Re: Preliminary Subdivision - West Chester Crossing  
# East Bradford Township – SD-10-19-16098

A Preliminary Subdivision Plan entitled "West Chester Crossing", prepared by ESE Consultants, Inc., and dated September 27, 2019, was received by this office on October 15, 2019. This plan is reviewed by the Chester County Planning Commission in accord with the provisions of Section 502 of the Pennsylvania Municipalities Planning Code. We offer the following comments on the proposed subdivision for your consideration.

Site Plan Detail, Sheet 7: Preliminary Subdivision - West Chester Crossing

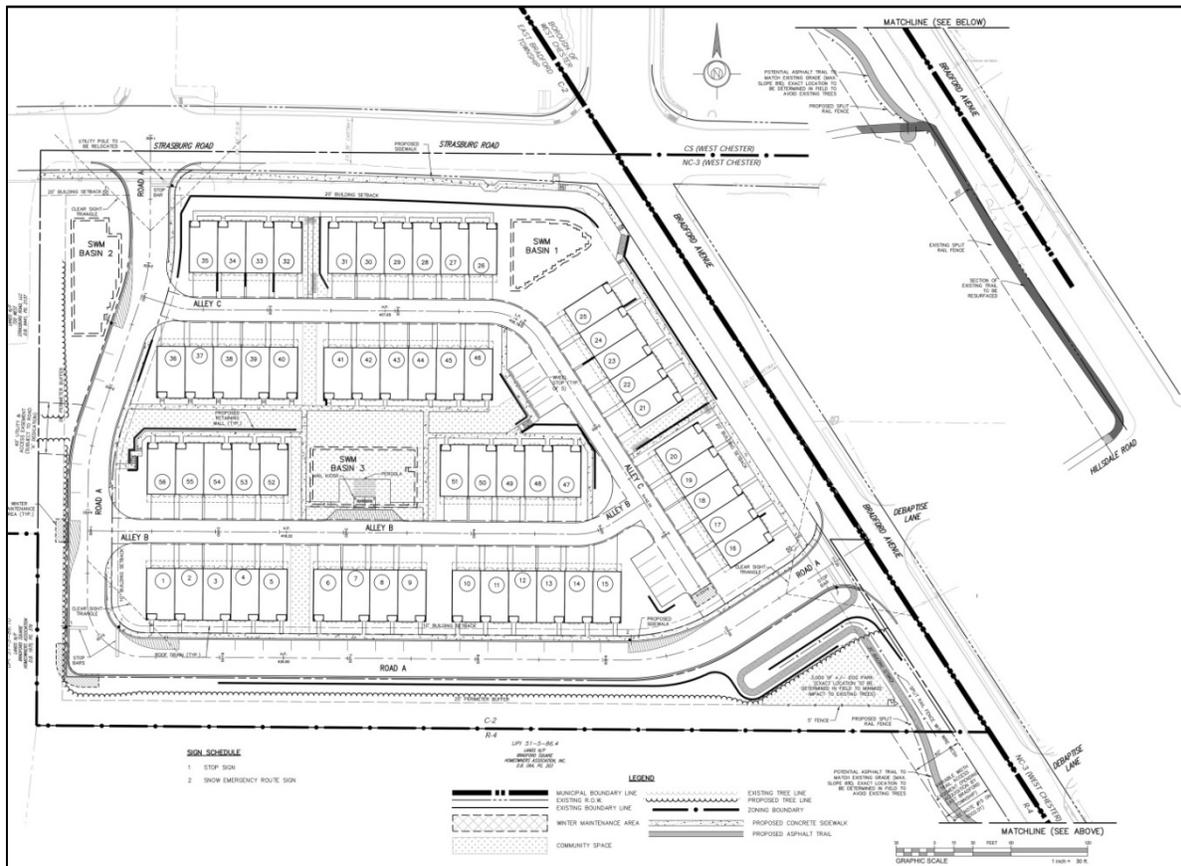
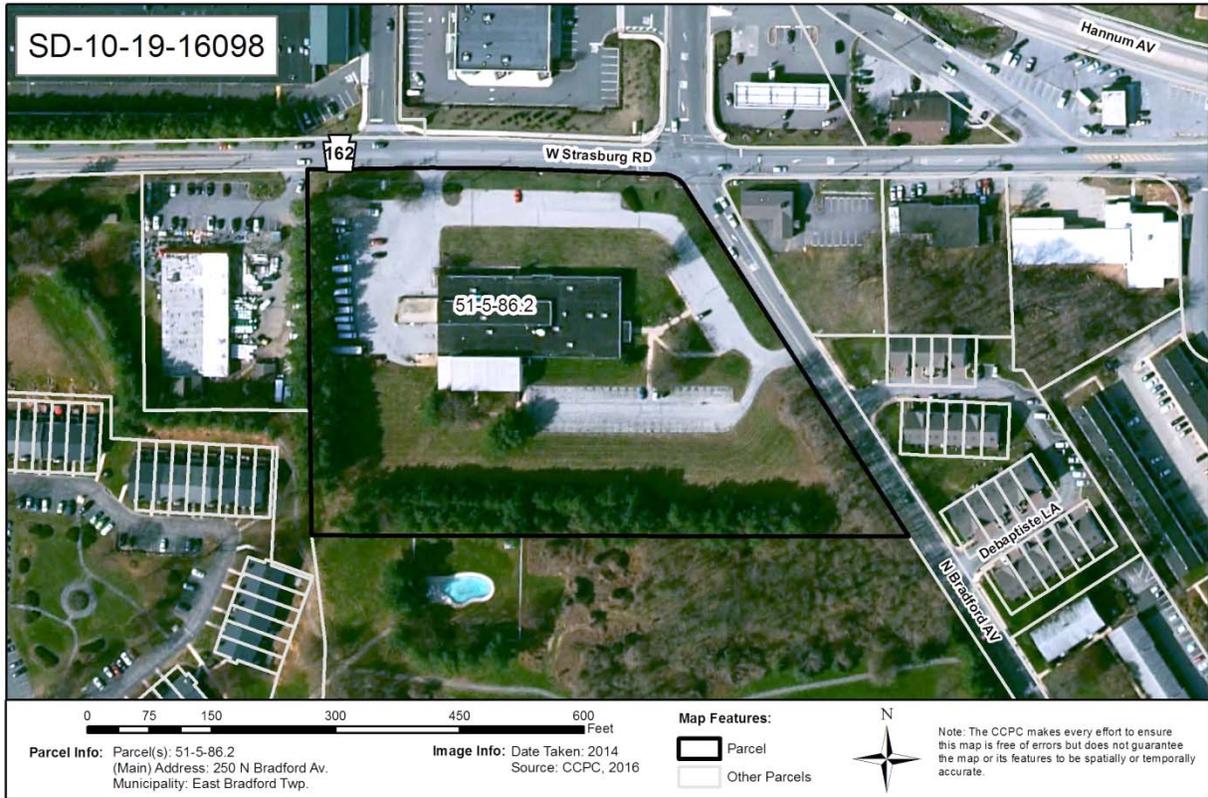
5. We acknowledge, and endorse, that sidewalks and crosswalk areas shall be provided along the Bradford Avenue and Strasburg Road frontages, with pedestrian access provided to the adjoining ACE Hardware Store to the west along Strasburg Road. Sidewalks are an essential design element in the Suburban Landscape.

Condition #15 of the conditional use decision states that, subject to PennDOT approval and the consent of West Chester Borough, the applicant shall provide raised, or otherwise safe, crossings across Strasburg Road at the new entrance across from the shopping center driveway, and also at the intersection of Strasburg Road and Bradford Avenue, north to south and east to west across the north leg of Bradford Avenue. The details of these pedestrian crossings, which are not shown on the current preliminary plan submission, should be provided on the final plan.

6. The site plan depicts the location of an asphalt trail corridor along Bradford Avenue from the Road A entrance to an existing trail on the adjoining Bradford Square development to the south. We note that a standard trail detail is provided on Sheet 17, which indicates that the proposed trail will be five feet wide. We also note that the proposed trail will be located within a variable width trail access easement on the adjoining site to the south. We recommend that all trail corridor location details be incorporated into the final plan, and we also recommend that any trails be constructed prior to the Township issuing any building occupancy permits for this development.

7. The plan depicts an existing 50 foot wide right-of-way on Strasburg Road and Bradford Avenue. While the prior conditional use plan depicted an additional 15 feet of ultimate right-of-way on the south side of Strasburg Road, this ultimate right-of-way is not shown on the preliminary plan submission. This should be clarified by the applicant. We recommend that the Township, in consultation with PennDOT and West Chester Borough, determine the appropriate right-of-way width to be dedicated for both Strasburg Road (Route 162) and North Bradford Avenue to accommodate all transportation elements. In addition to the proposed pedestrian improvements, the Transportation Impact Study recommends that the existing two-way center-left turn lane on Strasburg Road be re-striped in order to provide a 75 foot west-bound left turn lane at the intersection of Strasburg Road and Bradford Plaza/proposed driveway. The County Planning Commission's Multi-Modal Circulation Handbook (2016 Update) classifies Route 162 as a major collector road. The Handbook (page 183) recommends an 80 foot-wide right-of-way for major collector roads to accommodate future road and infrastructure improvements. The Circulation Handbook is available online at:

13. The site plan depicts the location of several retaining walls. The Township should verify that the design of the slopes is consistent with all ordinance requirements related to permitted grades, the design and specifications of retaining walls and slope stabilization.

23. Condition #24 of the conditional use decision states that the applicant shall depict on the plan locations for deposition of removed snow, ice and winter maintenance materials. While we acknowledge that the site plan depicts the location of three “winter maintenance areas,” the Township should verify that adequate areas have been set aside for snow storage.
